UC HASTINGS
COLLEGE OF THE LAW
EST. 1878

ITB #89-0167

200 McAllister 1st Floor Tenant Improvements

ADDENDUM #2

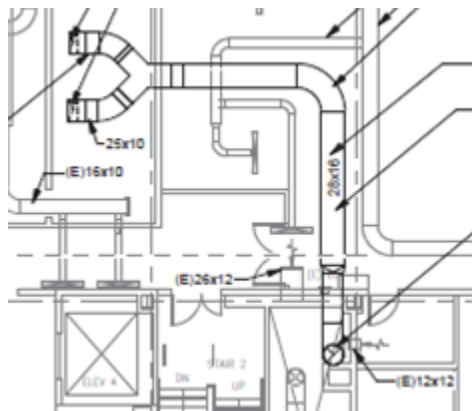
Q7: Sheet A6.1 identifies FT-2 as "Porcelain Wall Tile". This sheet also has WT-1 identified but this notation doesn't show up on any elevation.

A3: WT-1 is to be installed as shown on 3/A4.1 on the north restroom partition. FT-2 is the floor finish for Unisex Restrooms 116. Provide 6” Daltile porcelain tile cove base.

A7: See response #3 above.
